TOWN OF YORKTOWN, NY

**CATSKILL WATER SUPPLY DRINKING WATER FLUORIDATION
CONTRACT 19-2**

ADDENDUM NO. 1 – OCTOBER 24, 2019

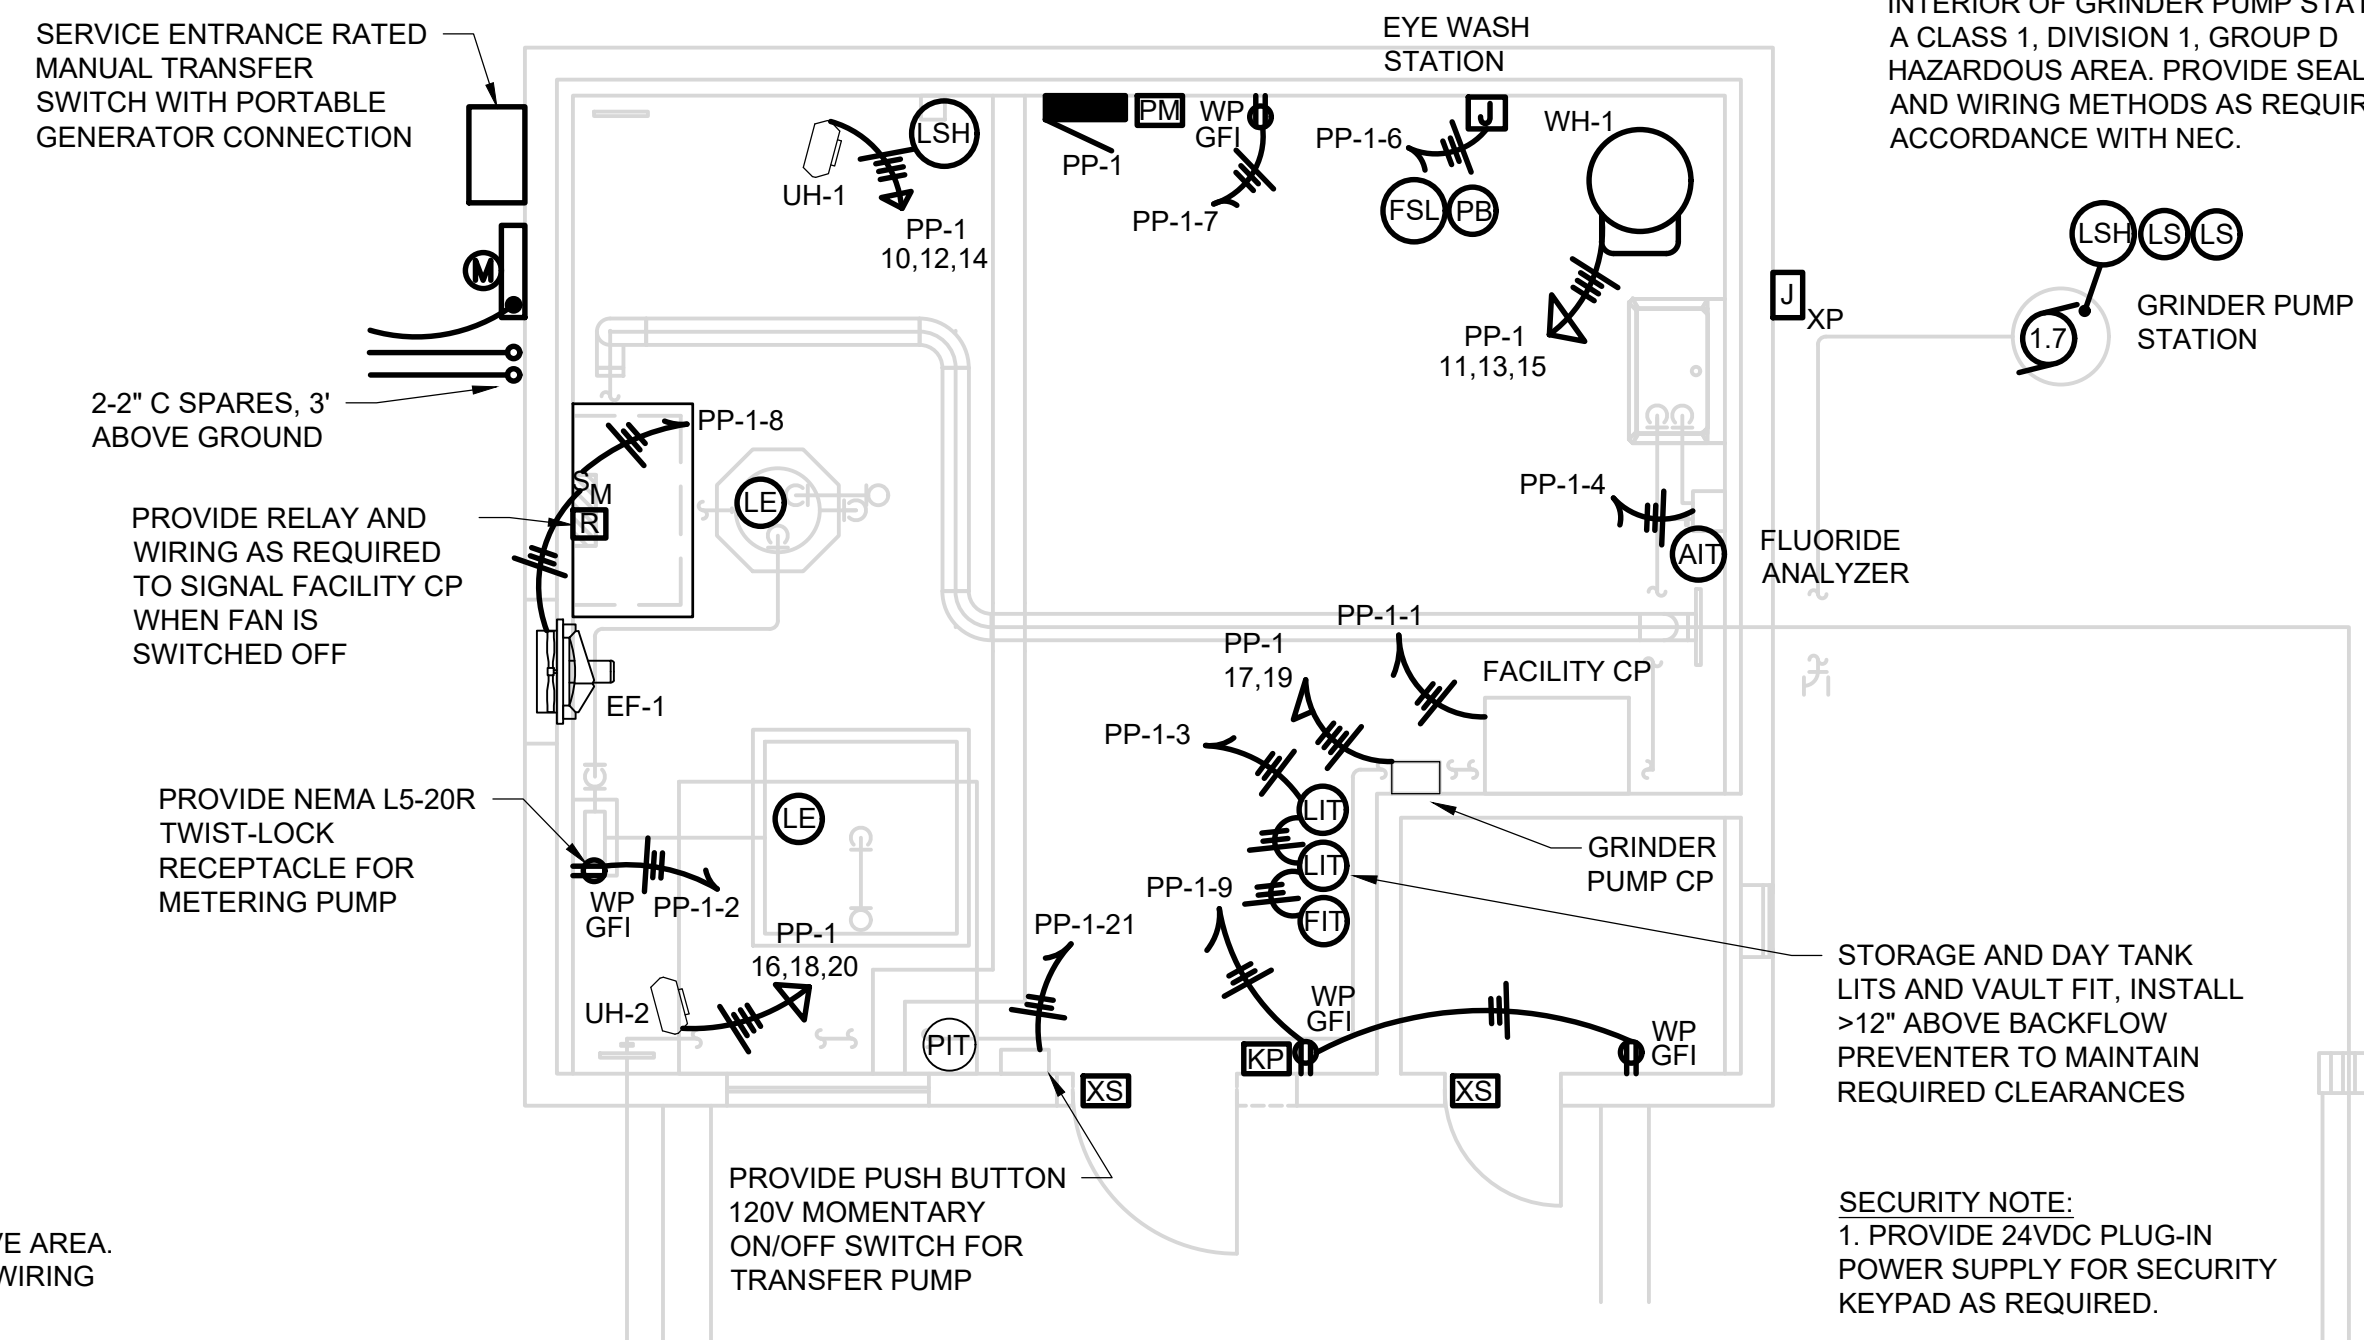
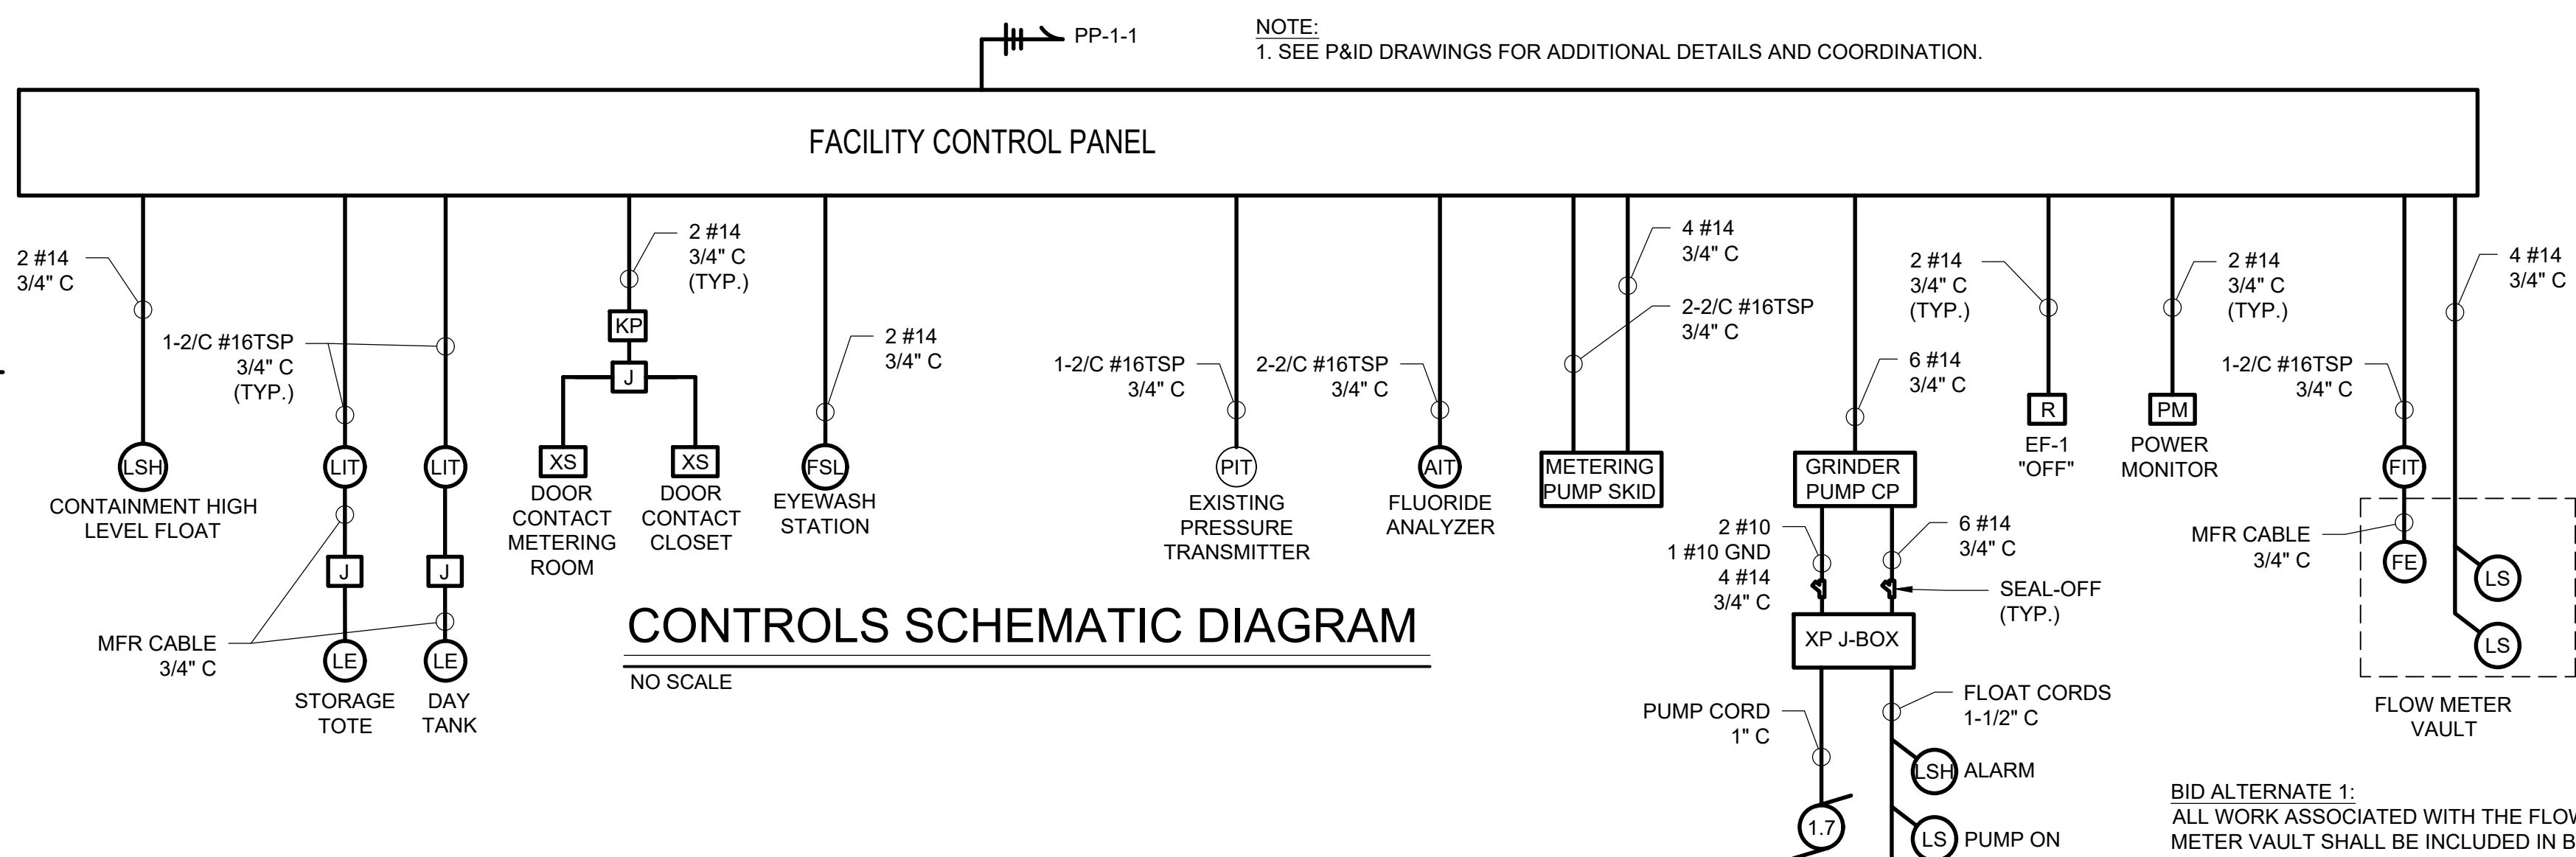
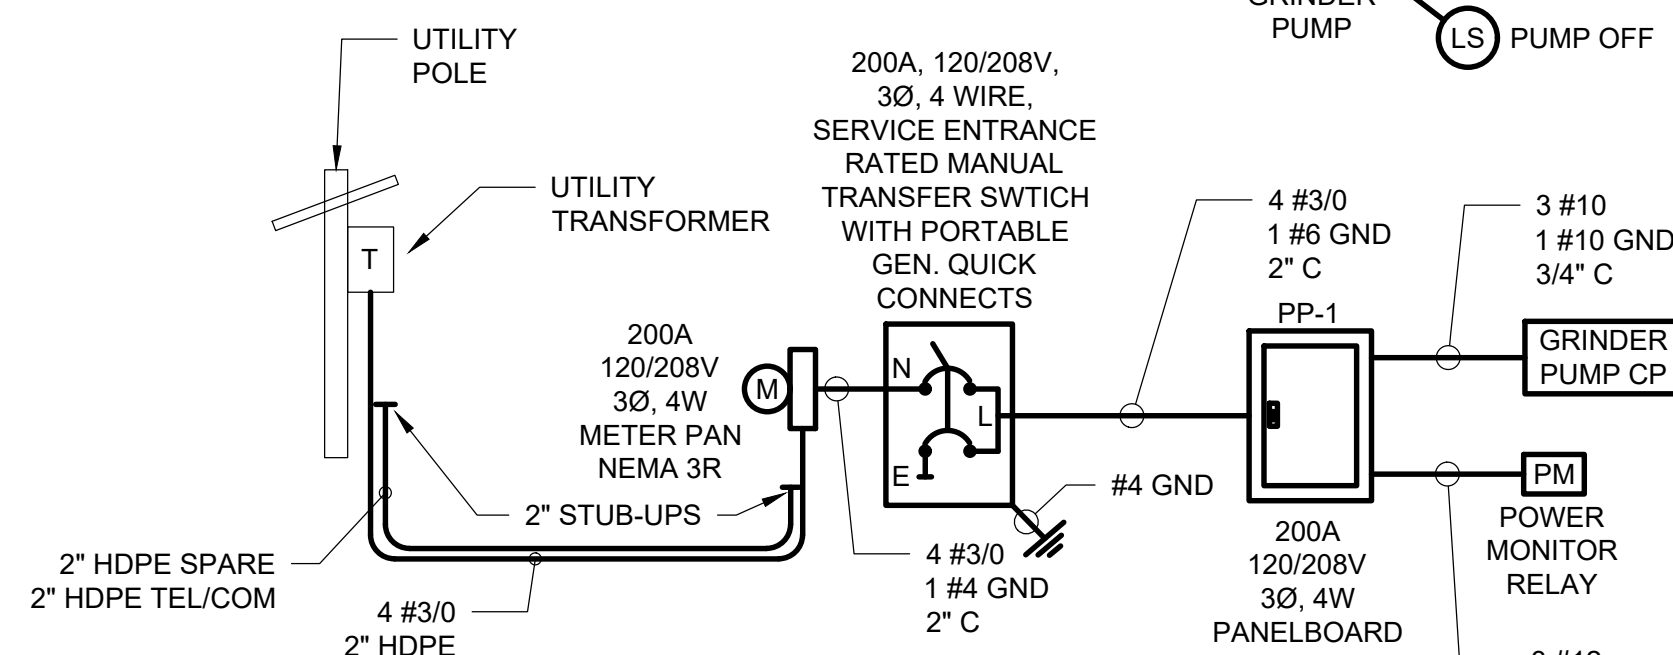
- b. General Note: Drawing sourced from Town as-built drawings. Any discrepancies shall be the responsibility of the contractor to remove and patch.
- E. Sheet E-03. Replace in its entirety with the Attached.

Question/Request	Date Submitted	Arcadis Reponse	Date Responded
Please provide type or spec for MFR cable (drawing E01 & E03)	10/17/2019	For the flow meter, a standard multi-conductor instrumentation cable is anticipated. For the grinder pump, it will be a standard pump cord.	10/24/2019
Note on Drawing E03 mention about P&ID for additional details. There is no P & ID drawings. Please clarify.	10/17/2019	Refer to Sheet G-13 (Instrumentation P&ID and Network Architecture.	10/24/2019
Please provide location for "Fill Station".	10/23/2019	The Fill Station has been eliminated. Please refer to updated Sheet E-03.	10/24/2019
Please specify who provide & install the Unit heaters, water heater & Fan.	10/23/2019	General Contract (Part 1) to provide and install the unit heaters, water heater and fan.	10/24/2019
Please provide wiring "size" & type for PB. The control schematic diagram doesn't show.	10/23/2019	Clarification: the "PB" is an integral alarm reset pushbutton on the eyewash/shower.	10/24/2019
